PNF Installation note

Number: PNFIN08241001

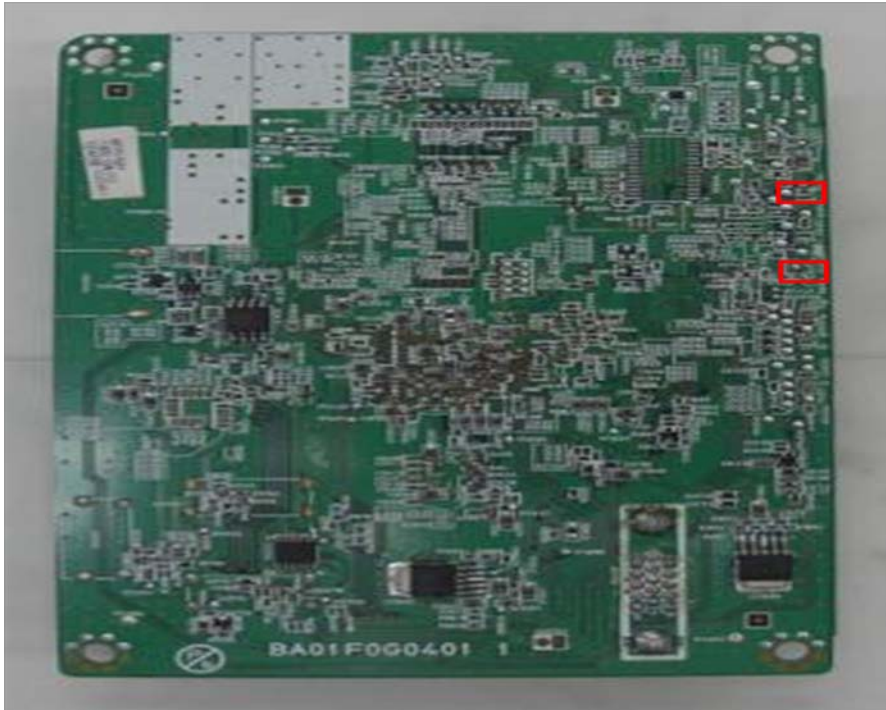
Symptom: Volume goes up or down without any buttons on the remote or keyboard being pressed.
Set shuts off and comes back on.

Remove capacitors C3714 and C3718 on the digital main board if they are present. Later stock may not have these capacitors.
